Applicant:	Strong et al	§
		§ Art Unit: 3653
Serial No:	10/774,303	§
		§ Examiner: Joerger, Kaitlin S.
Filed:	6 Feb. 2004	§
		§ Atty Docket No: SC 082
For:	Shaker Screen and	§
	Clamping System	§ Conf. No. 5404
		§

RESPONSE TO OFFICE ACTION MAILED 2/28/2006

US Ser. No. 10/774,303
 Marked-Up Sheet showing changes

Fig. 55B

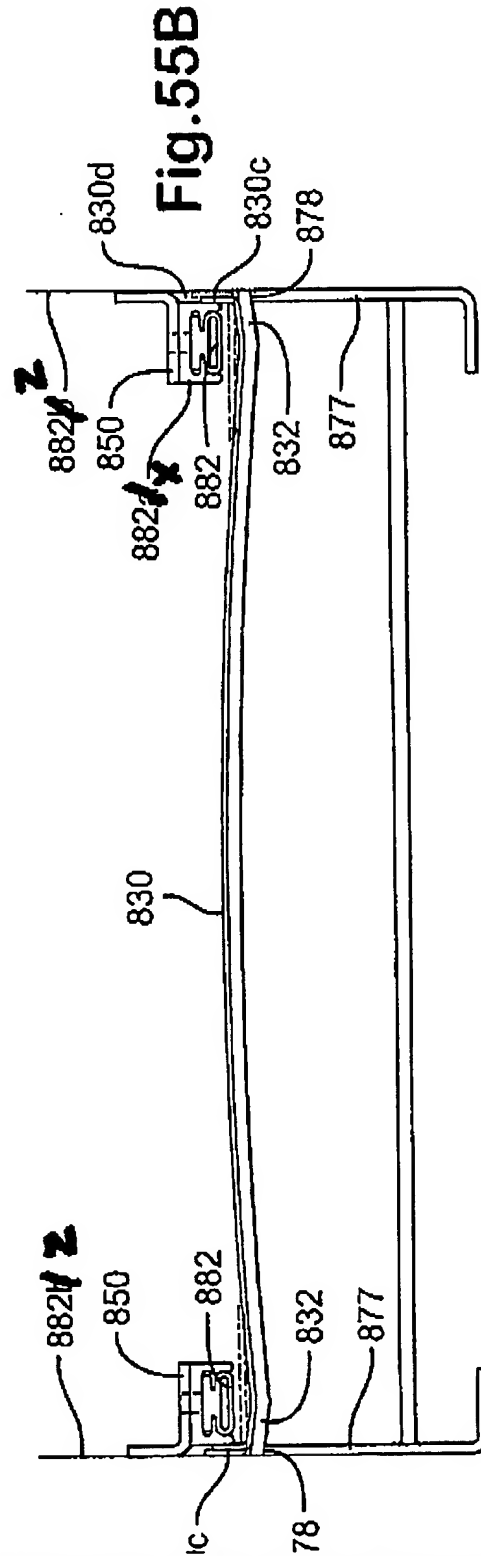
Numerals 882a and 882b remain which are used to indicate the bladders, uninflated and inflated. The brackets on Page 19, line 7 of the Specification are now indicated by numeral 882x; and the walls on Page 19, line 8 are now indicated by numeral 882z. Marked-up and replacement pages 19 are submitted herewith, along with a replacement drawing sheet with corrected Fig. 55B with new numerals 882x and 882z.

94. As shown in Fig. 55C, the screen assembly 830 may, optionally, have side lips or hooks 830c which are selectively
5 releasably positionable in gaps 830d between brackets ~~882a~~ 882x holding the bladders 882 and side walls ~~882b~~ 882z of a vibratory separator. Any known shape or configuration for any known hookstrip and/or hooks may be used with associated well-known hook or hookstrip holding apparatus.
